TRANSMITTAL OF EIGHTH TAAG REPORT - Hmb-173-84

DRAFT
EIGHTH REPORT
OF THE
Technical Assistance and Advisory Group (TAAG)

Three Mile Island Unit 2 (TMI-2)
For the Period December 1, 1983, to April 1, 1984

DOSE FROM A SINGLE ROD DURING DEFUELING OPERATIONS

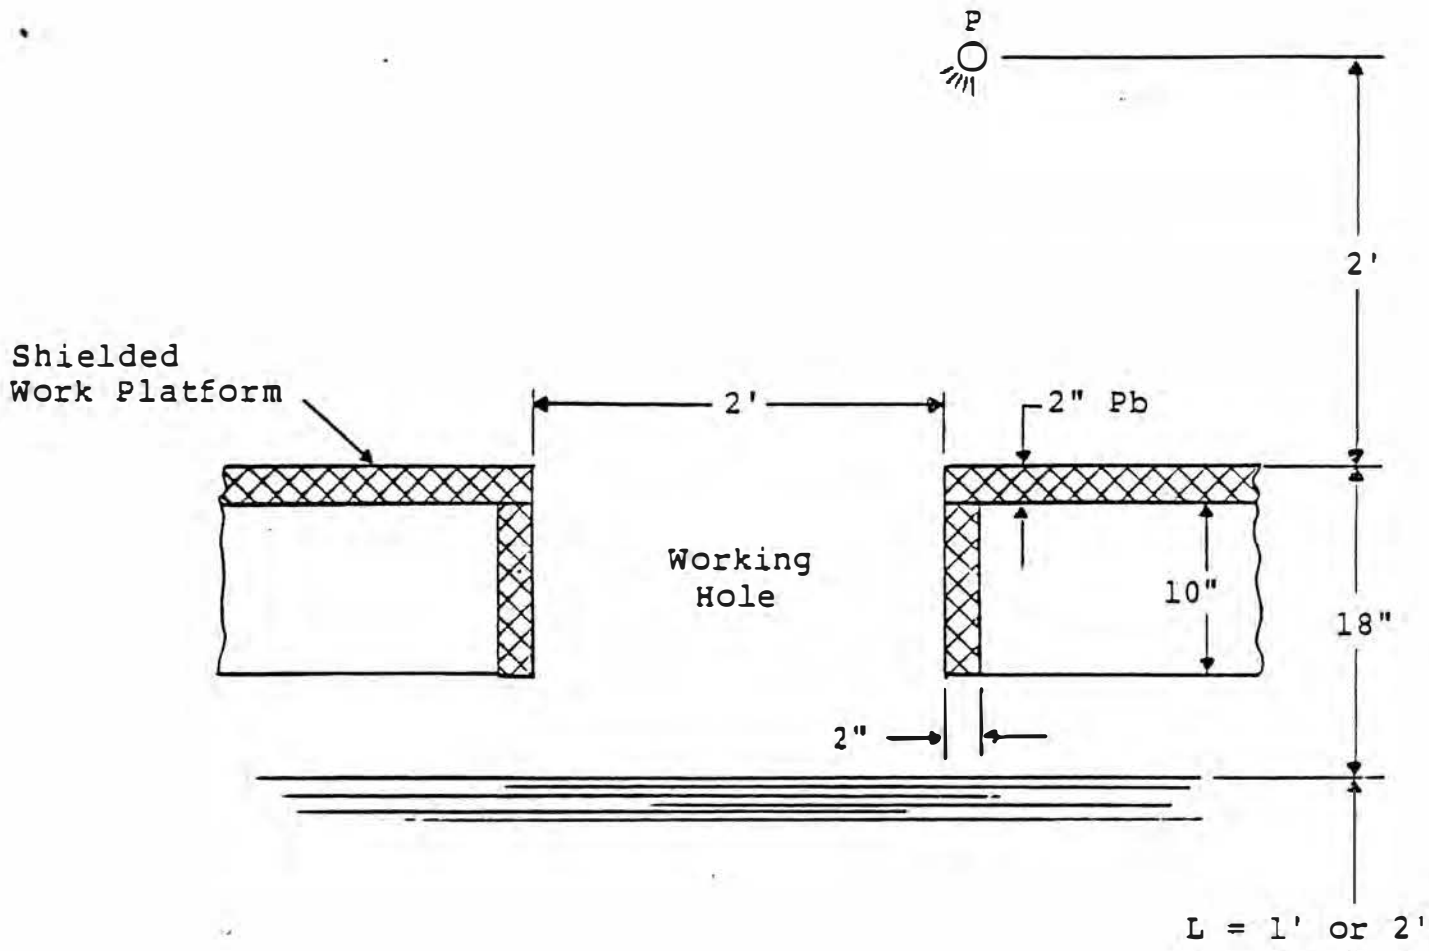
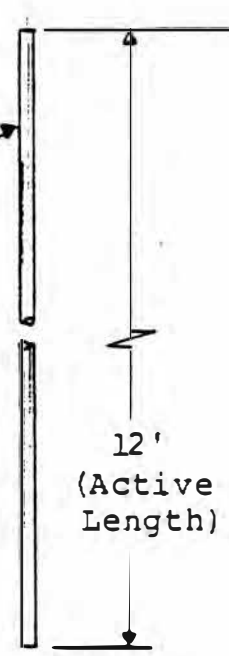
3. An assessment was also made of the radiation level resulting from handling a maximum burn-up fuel rod assuming no leaching or loss of fission products (see Figure 7). As can be seen in this figure, such a rod, if raised to 1 foot of the water surface, would result in a radiation level of about 370 mr/hr at work elevation and about 50 mr/hr if 2 feet of water is maintained. Based on the depth of water available in this concept, sufficient water depth should be available to permit handling of fuel pins, debris and canisters to still maintain low radiation levels in the work areas.

CONCEPTUAL LAYOUT OF LOOSE DEBRIS VACUUMING SYSTEM

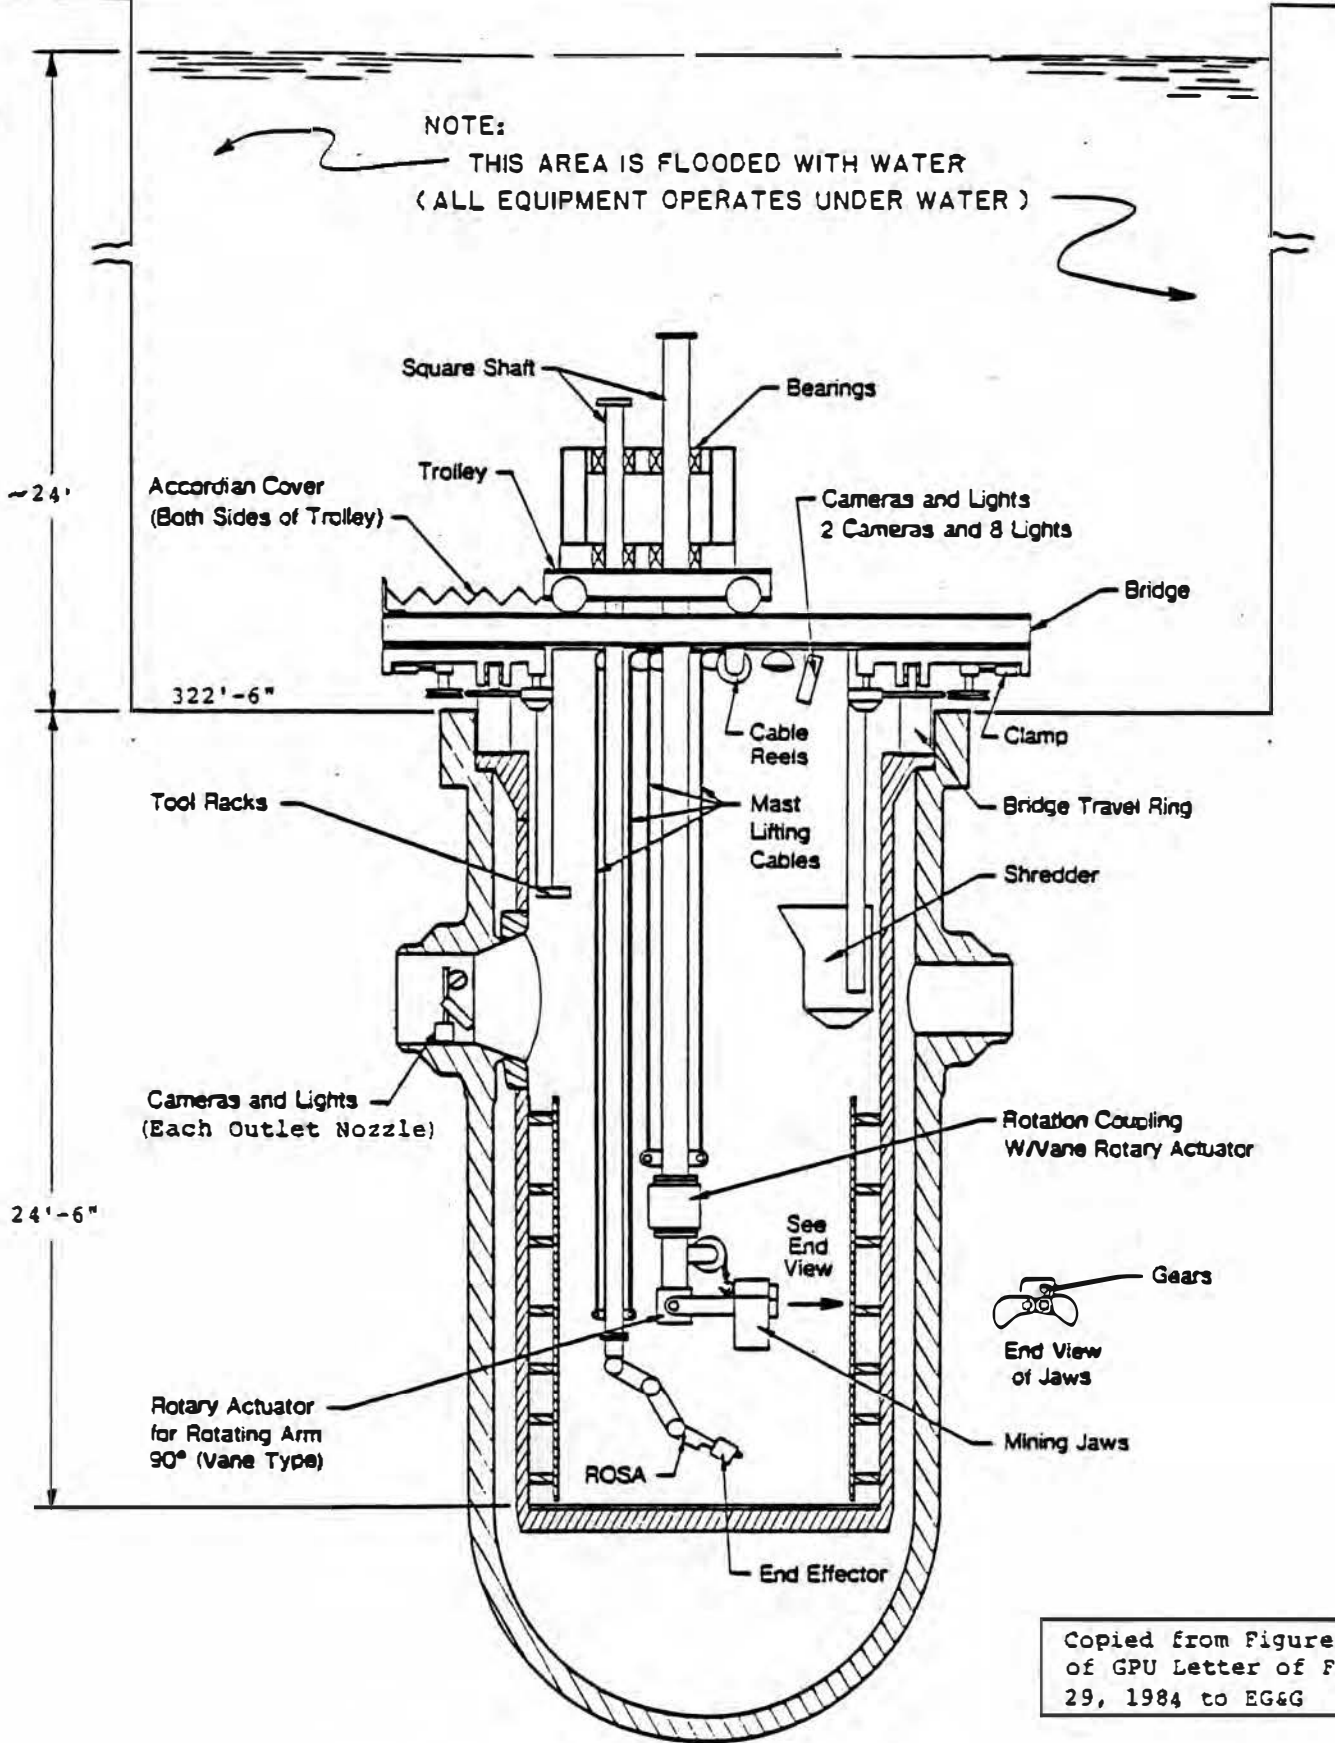
Presently there is about 3 feet of relatively loose and small size debris resting on the TMI-2 core. It is proposed that one of the first actions after the plenum has been removed is to vacuum up this loose debris. Figure 9 shows conceptually how such a vacuuming system can be installed and used with a long handled tool defueling concept. In this concept a long handled tool (with vacuum suction hose, TV, and lights mounted on the end of the tool) can be manually manipulated through a working slot to vacuum the debris. Sufficient direct visibility will most likely be available for this type of operation since water is relatively shallow and fine tool positioning is not required. If direct visibility should be a problem, the TV camera should provide adequate viewing. The vacuum system pump unit and bracket assembly to support the canisters are positioned in the reactor vessel by suspending them in an access port of the shielded work platform. The canisters are positioned in the access port adjacent to the working slot. Thus, by using an off-set hand tool in the working slot, canisters can be installed and moved to the transfer boot for removal from the reactor vessel.

PRESENT REFERENCE
TMI-2 AUTOMATIC /REMOTE DEFUELING CONCEPT
(REACTOR CAVITY FLOODED)

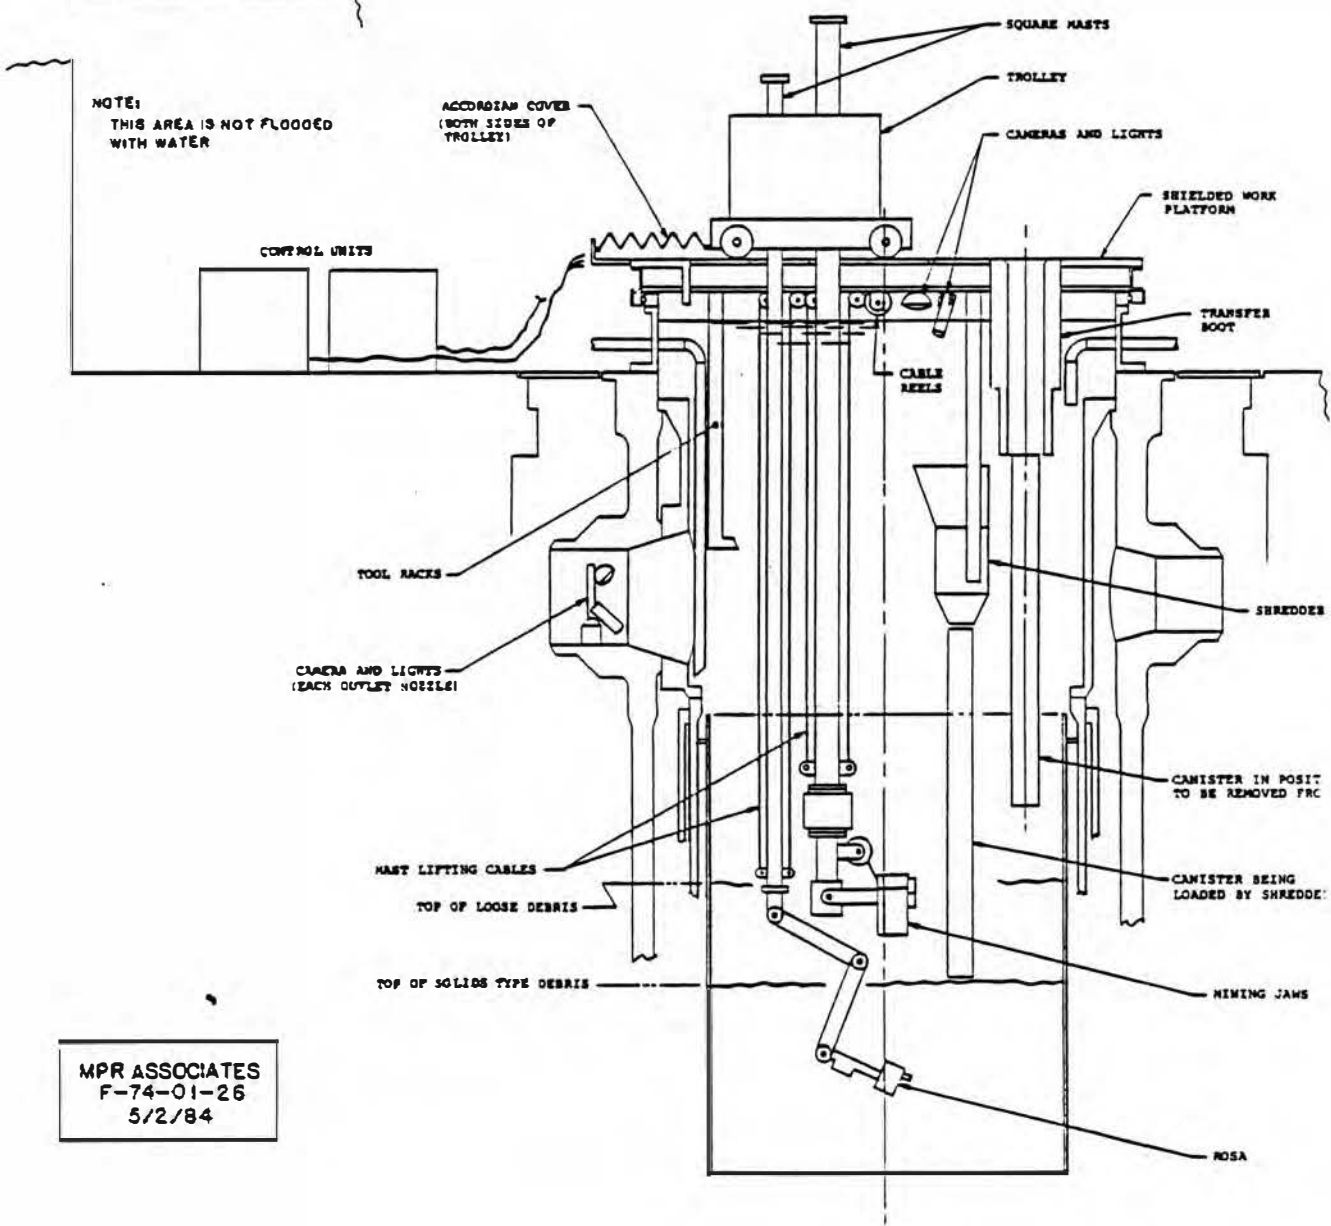
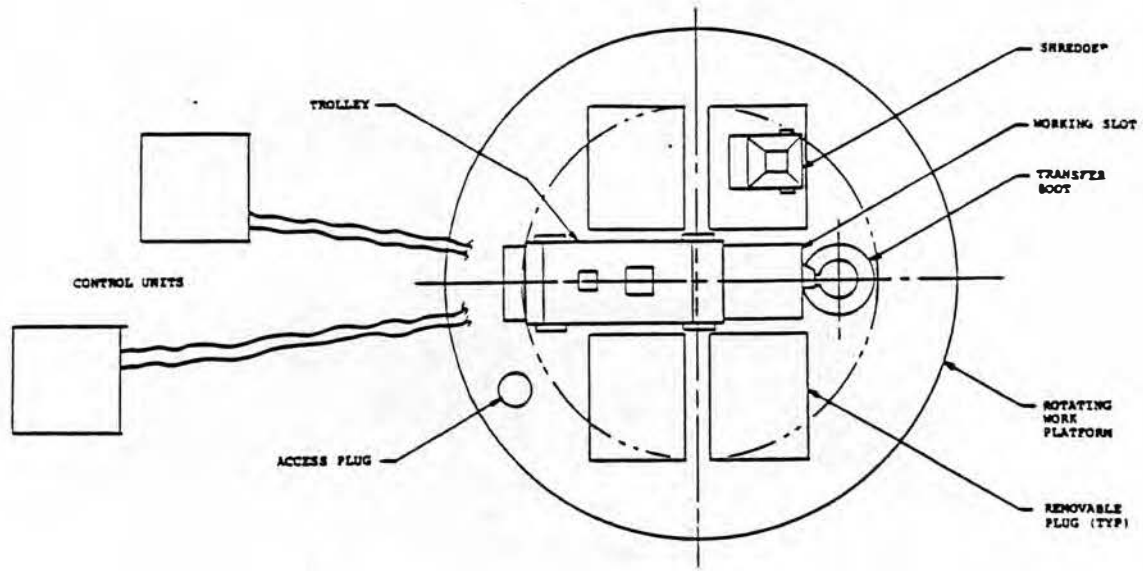
The present reference TMI-2 defueling concept uses automated/remote tooling. The tooling is positioned in the reactor vessel flange under about 23/24 feet of water. The reference tooling concept is shown on Figure 10A.

USING AUTOMATED / REMOTE DEFUELING EQUIPMENT
 WITH THE LONG HANDLED TOOL DEFUELING CONCEPT

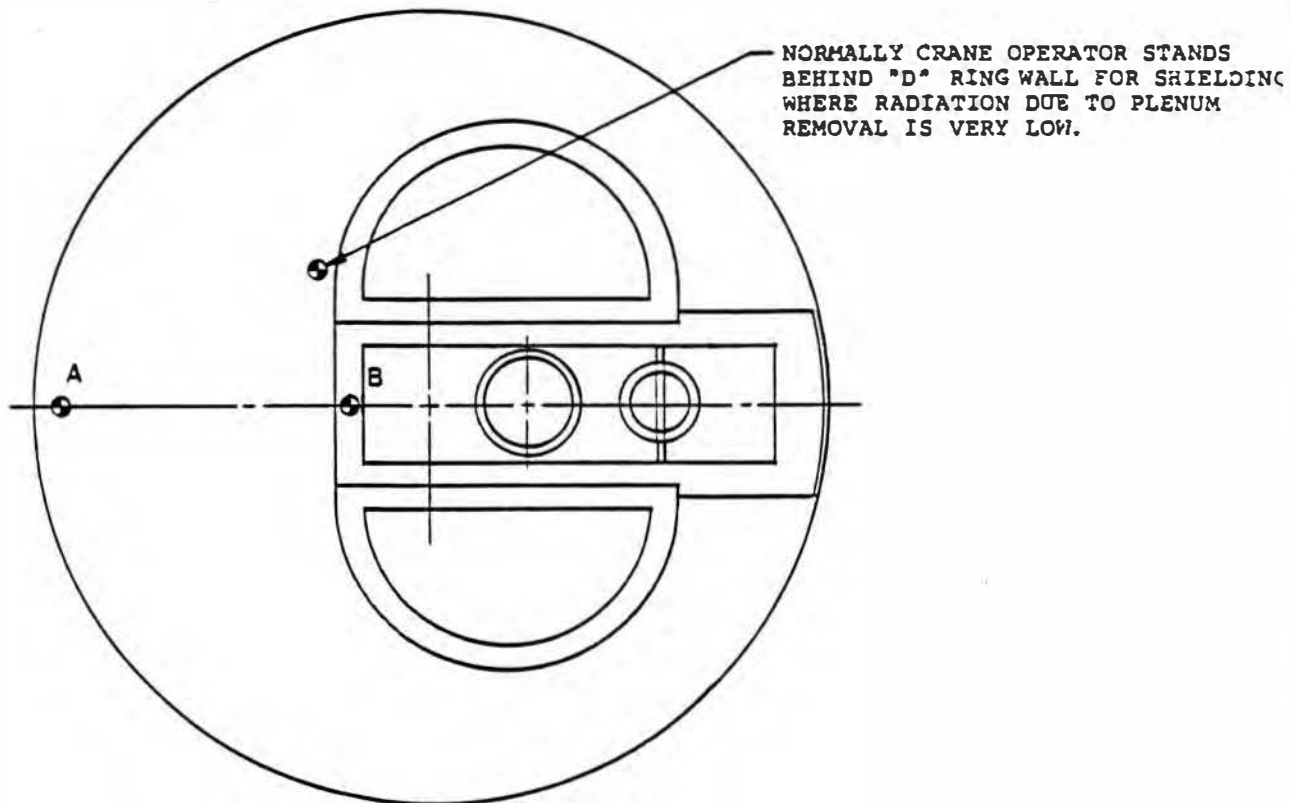
As indicated previously, it is desired that the long handled tool defueling concept should not preclude the use of automated/remote tooling if it is reliable; however, this defueling concept should not be dependent on it. Figure 10B shows conceptually how automated/remote tools can be used in conjunction with the shielded work platform of the long handled tool defueling concept.
